WOLF CREEK

Reference: Letter dated August 15, 1988 from P. W. O'Connor, NRC,
to B. D. Withers, WCNOG
Subject: Docket No. 50-482: Pump and Valve Inservice Testing
Program Relief Request

**RESPONSE TO REQUEST FOR ADDITIONAL INFORMATION
RELATED TO RELIEF REQUEST PR-11**

CHARACTERISTIC CURVE
CERTIFIED TEST DATA
GOULDS PUMPS, INC.
SENECA FALLS, N.Y.

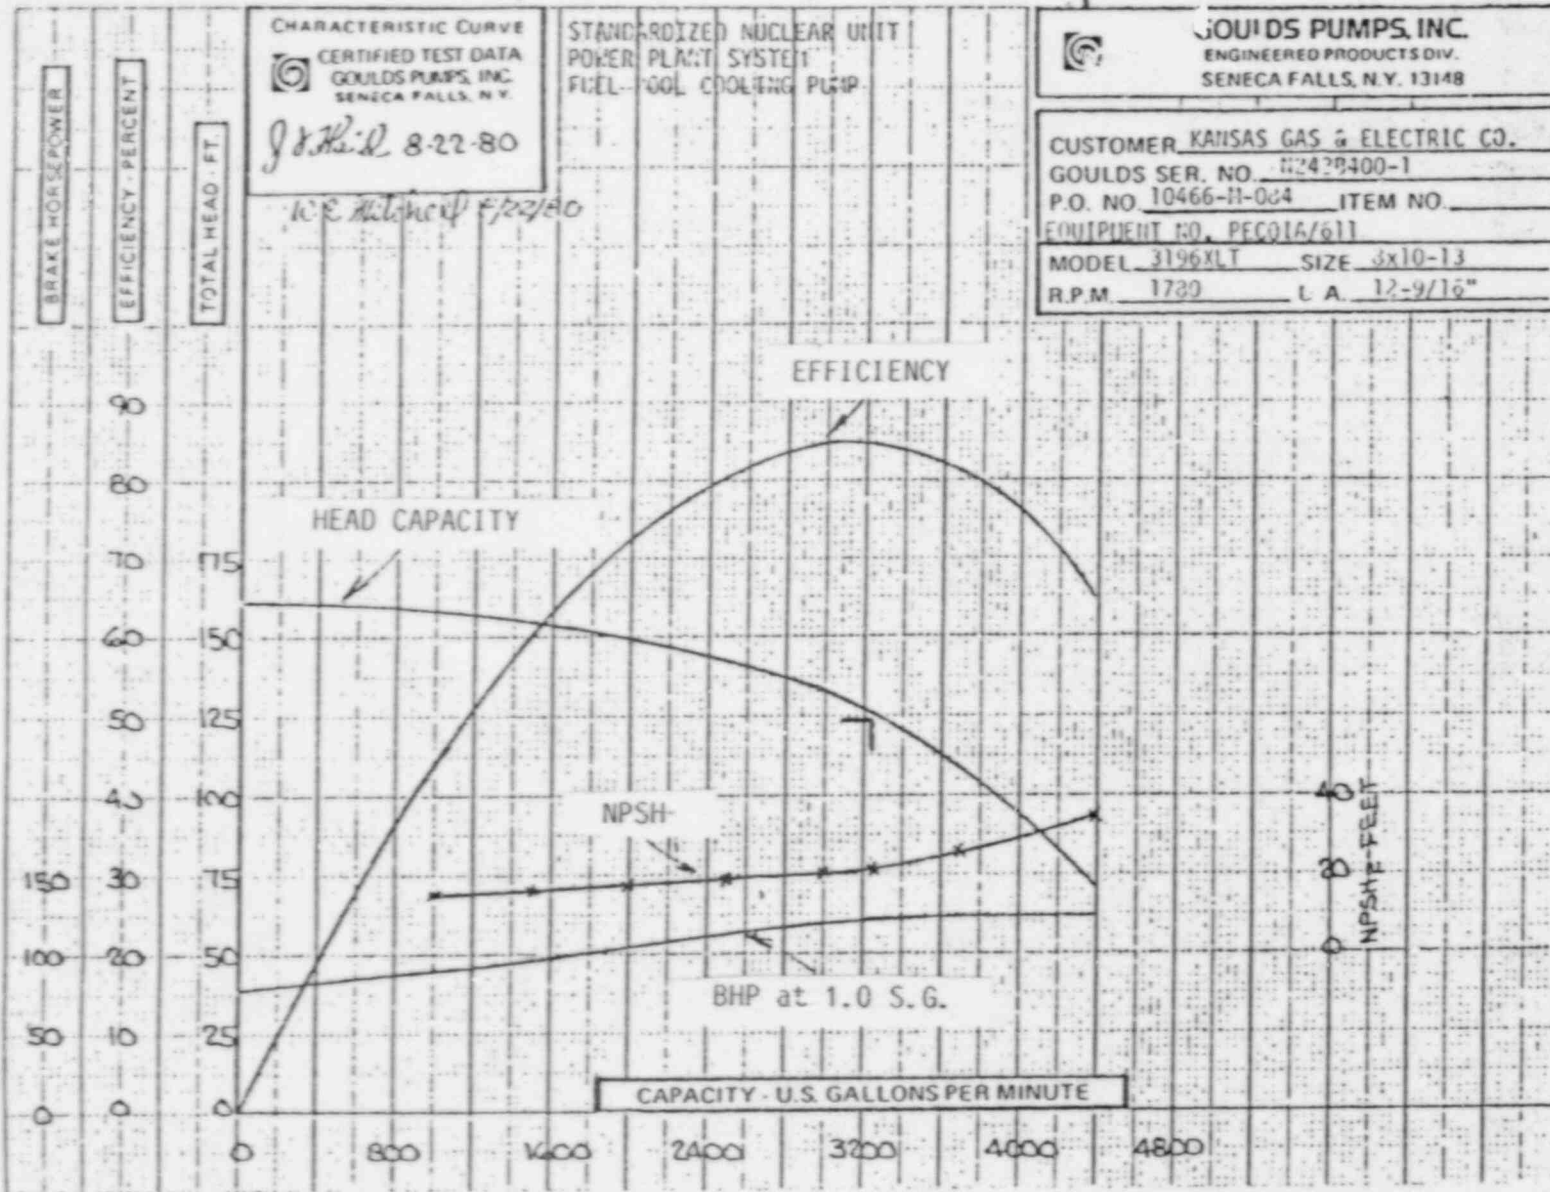
1. Attachment 2 provides the manufacturer's pump curve for fuel pool cooling pump 01A. The manufacturer's pump curve for fuel pool cooling pump 01B is identical.
2. Attachment 3 provides in table format the reference differential pressure (d/p) versus actual d/p data which is used to trend the pump test data. The reference d/p is obtained during surveillance testing by measuring the flow rate then obtaining the d/p from the WCGS fuel pool cooling pump curves in Attachment 4.
